TO: Mercedes-Benz Dealer Principals, General Managers, Sales Managers, Service Managers, Parts Managers	FROM: Gregory Gunther, Department Manager, Vehicle Compliance and Analysis, Engineering Services
RE: Recall Campaign Launch Notification Fastening of Rear Door Trim Bar MY20 GLE-Class (167 platform) and GLS-Class (X167 platform)	DATE: October 25, 2019

Recall Campaign Launch Notification			October 25, 2019
Campaign No. :	NHTSA ID	Campaign Desc. :	Fastening of Rear Door Trim Bar
2019100011	19V709	19P6792001	
<p>This is to notify you of a Recall Campaign Launch regarding the rear door trim bar on 13,797 Model Year (“MY”) 2020 GLE-Class and GLS-Class (167 platform) vehicles. The recall campaign will be visible on the www.safercar.gov website and may generate questions from customers. Affected VINs will be flagged in VMI as “OPEN” on October 25, 2019.</p>			
Background			
Issue	<p>Daimler AG (“DAG”), the manufacturer of Mercedes-Benz vehicles, has determined that on certain Model Year (“MY”) 2020 GLE-Class (167 platform) and GLS-Class (X167 platform) vehicles, the fastening of the rear door window trim bars might not meet current production specifications. Under certain driving condi

Figure 1

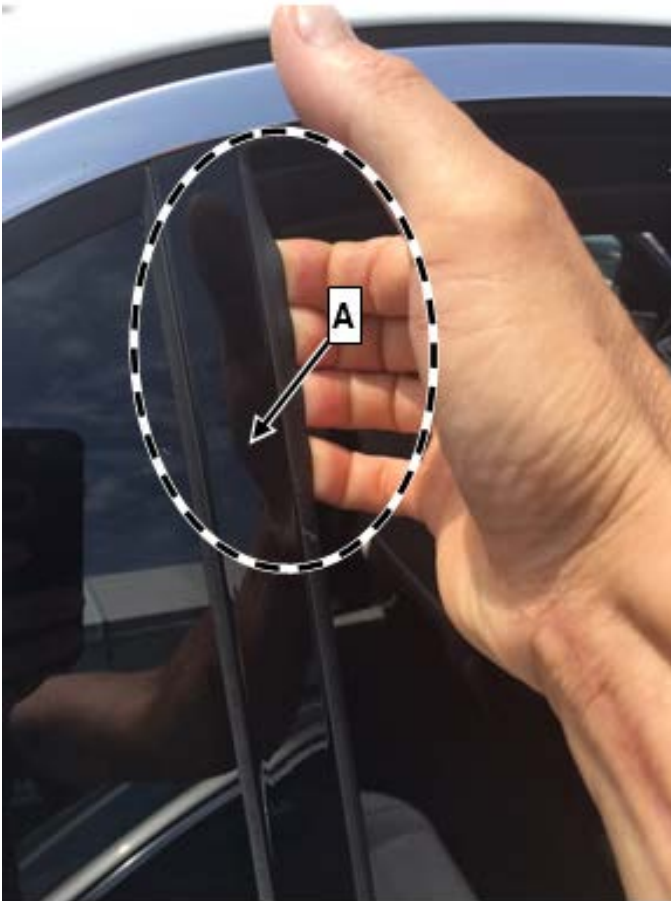
1. Lower side window on right and left rear door.
2. Check window divider (**A, figure 1**) on right and left for tight seating.

i To do so, grasp the window divider in the upper area by hand (**figure 1**) and support with the thumb on the fixed window (**figure 2**). After this, carefully pull the window divider to the outside with minor force.

i The window divider should not detach due to the minor force. Ensure that there is at least a 1mm clearance between the chrome trim strip (**B, Figure 2**) and window divider (**A, Figure 2**), and that the window divider does not jam under the chrome trim strip of the window frame (**B**). If the window divider jams under the chrome strip, the test results in a false positive.

- a. Window divider (A) detaches due to slight tractive force: Carry out work procedure.
- b. Window divider (A) does not loosen due to slight tractive force: **End measure.**
